## **Appendix E:      Requests for Information**

### Hope Bay Mining Project

Subject:	North Dam SRK Engineered Drawings	Project Zone/Area:	Hope Bay / Doris North
Company:	Nuna Logistics Ltd. (Nuna)	Station/Location:	Doris North - North Dam
Attention:	Kevin Mather/Doug Fielding cc. SRK Engineering	Discipline:	Civil

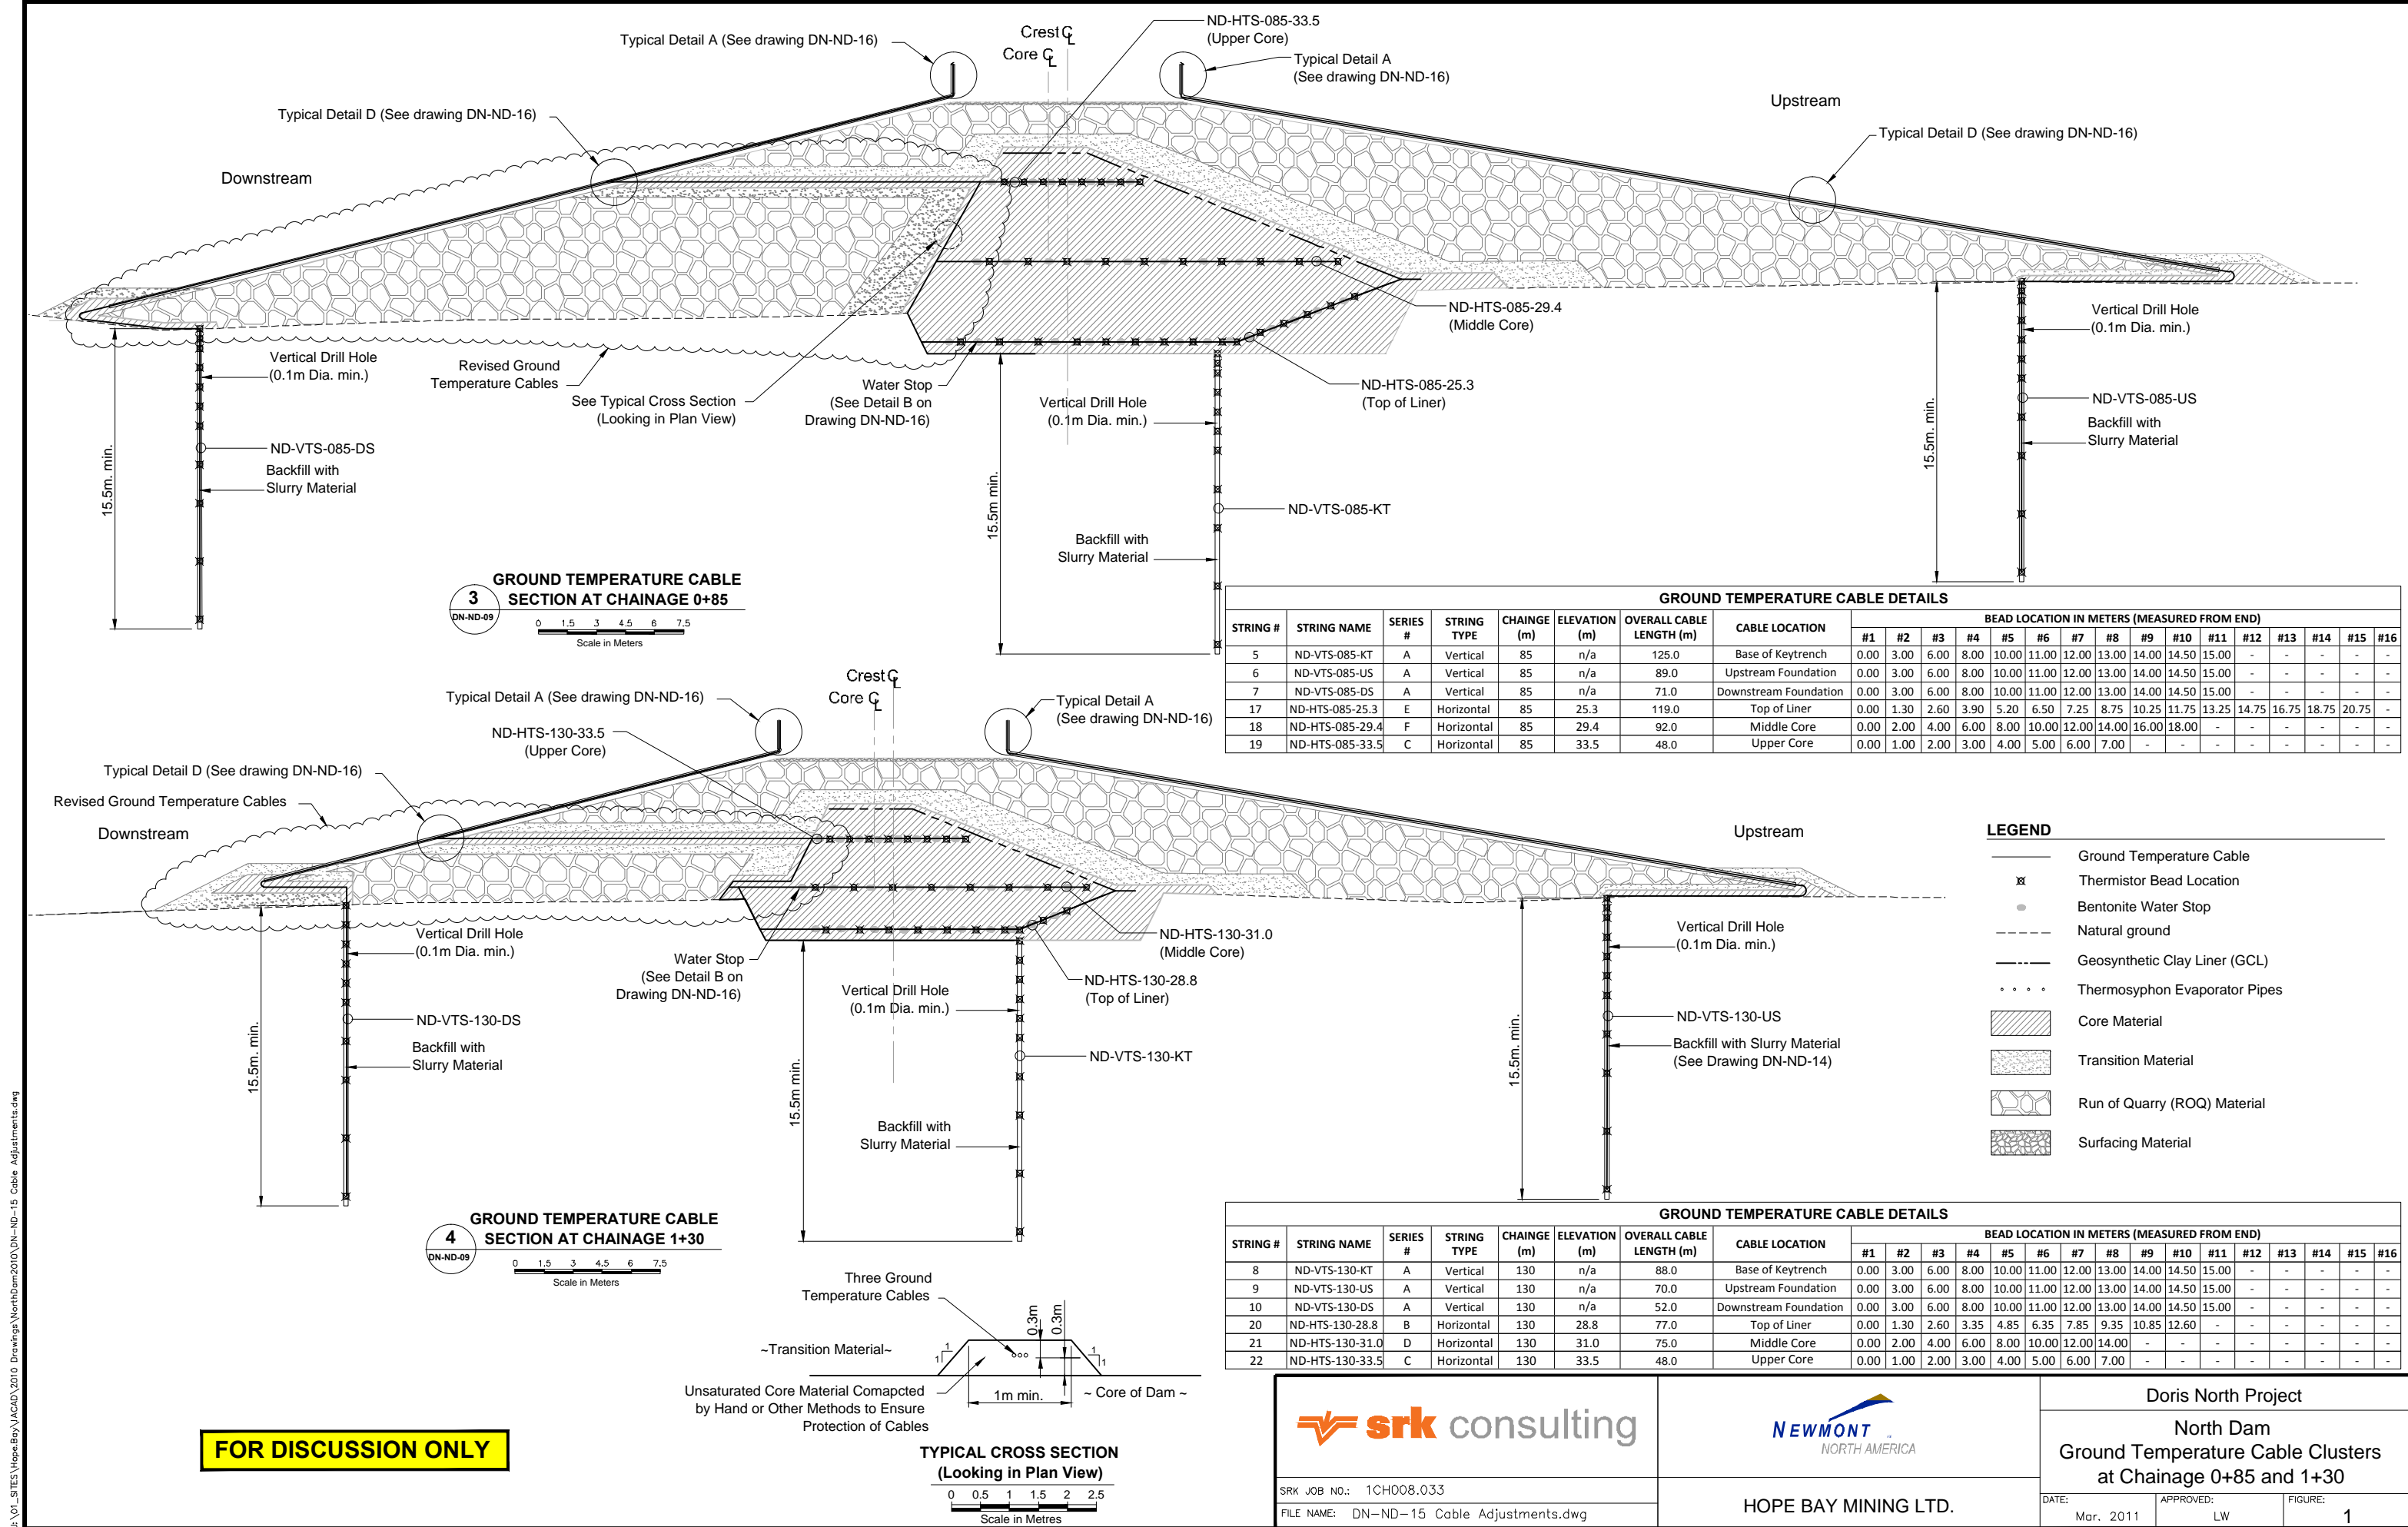
Please assess the materials and dimensions that illustrates the cross section (Dwg. DN-ND-09) in which the cable extensions will be buried in the horizontal plane to extend to the downstream slope of the dam.

Response:			
SRK does not see an issue with the re-routing if the ground temperature cables as proposed. RST [the supplier of the ground temperature cables] confirmed the increased number of bends will not be an issue as the cable is constructed of multi-strand copper wire. Care should be taken so cable is installed with smooth bends. As the new cable routing will be along the outer edge of the Dam's core the cables will have to be protected from the ROQ shell by placing unsaturated compacted core material around the cables as the ROQ shell is being constructed. This is shown in the attached figure.			
Responsible Newmont Representative:	Lowell Wade	Sign:	March 29, 2011
	Print:		Date:

Original Drawings Stamped and Signed by Engineer		SRK Consulting Engineers and Scientists		NEWMONT NORTH AMERICA		HOPE BAY MINING LTD.		Doris North Project		DRAWING TITLE: North Dam Thermosyphon Details		DRAFT SKETCHES/NOTES		HB+T-CIV-CIV-OND-0047		SHEET 28 OF 29		REVISION NO. 2

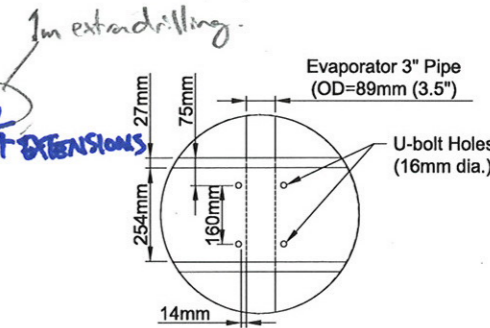
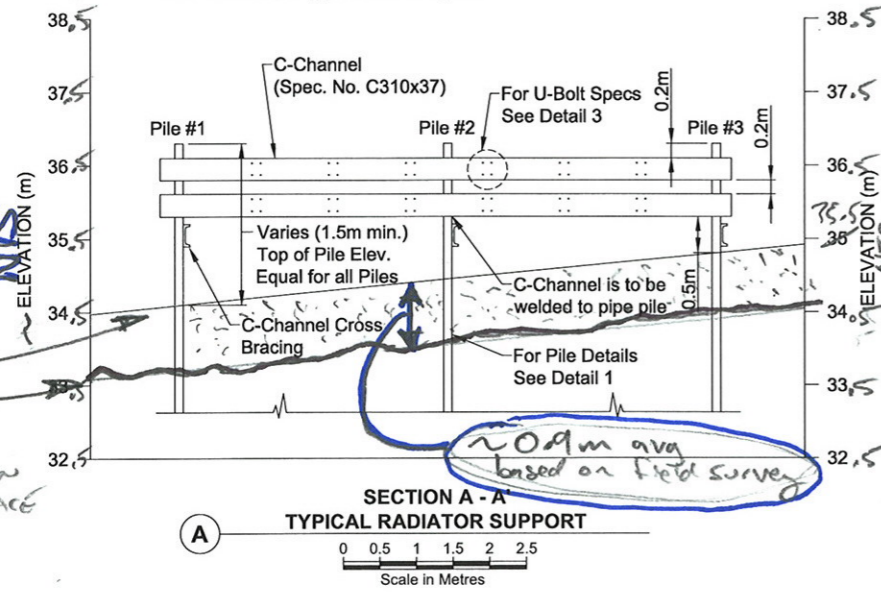
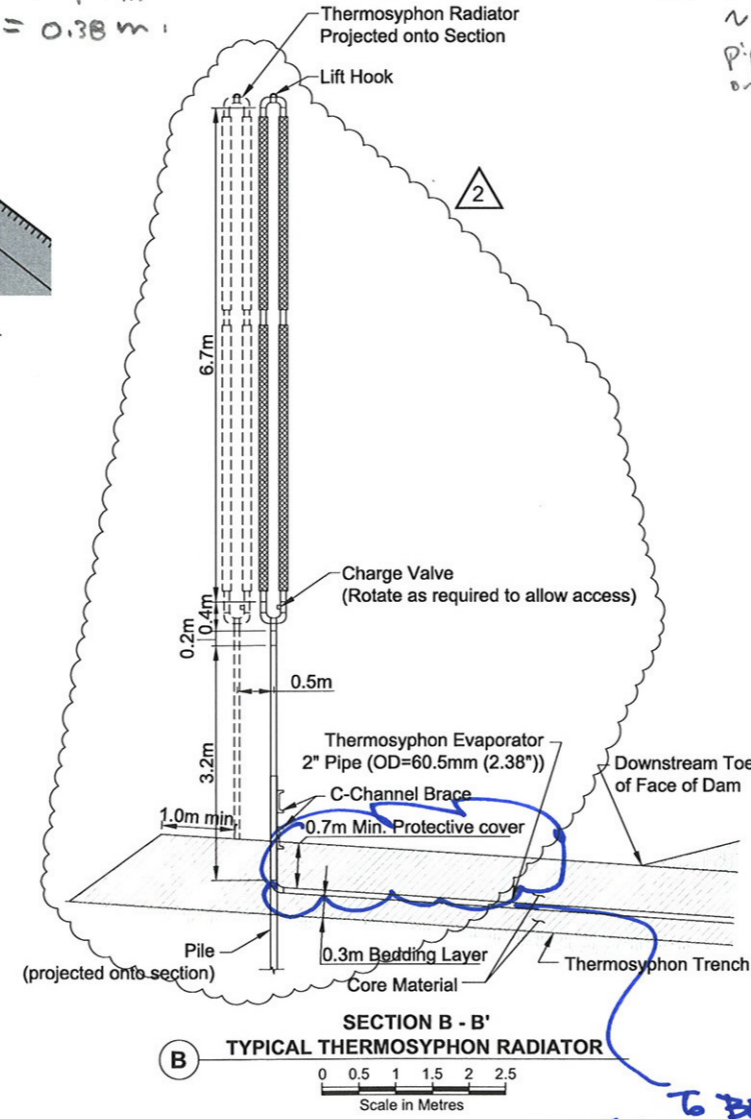
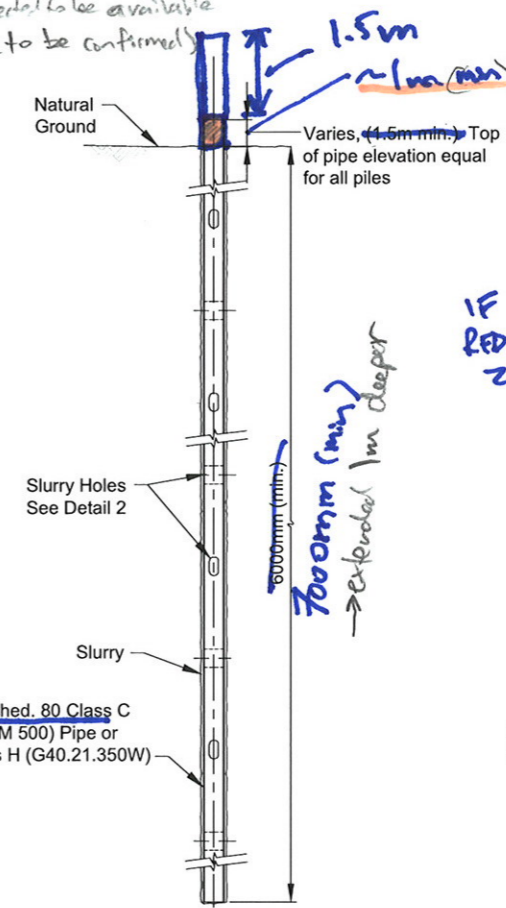
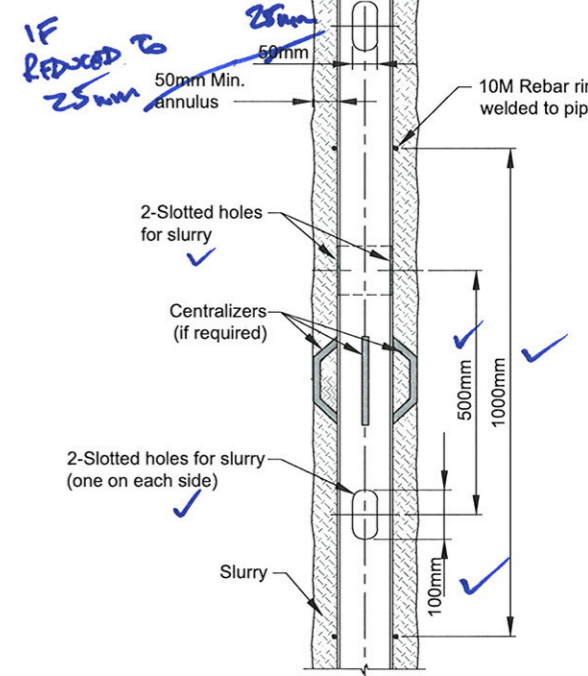
- **Background:** As outlined in SRK's technical specifications: A minimum 4" (102 mm) nominal Schedule 80 pipe is recommended. The pile installation holes shall be drilled to a diameter at least 100 mm larger than the outside diameter of the pipe. Further the drawing shows the annulus as being 50mm (on either side or surrounding the pile).
- As of April 1<sup>st</sup> only a 6 ½" drill bit was on site.

To assist in reduce further operational delays SRK indicated that with pile fabrication modifications and an increased pile embedment depth a 25mm rather than a 50mm annulus (on both sides of the pile) would be acceptable for the North Dam radiator piles. Details on pile embedment and required fabrication modifications, for use with a 25mm annulus, are presented below:

- Final pile lengths are a minimum of 9.5m at the highest point and a maximum of 10.5m at the lowest point (based on neat lines).
- It is recommended that to account for any potential over drilling and to assist with easy welding the c-channels and cross bracing that an additional 0.5m allowance be added onto the piles. Therefore pile lengths are expected to be in the range of 10m minimum to 11m maximum (or extensions are expected to range from 2 to 3m).
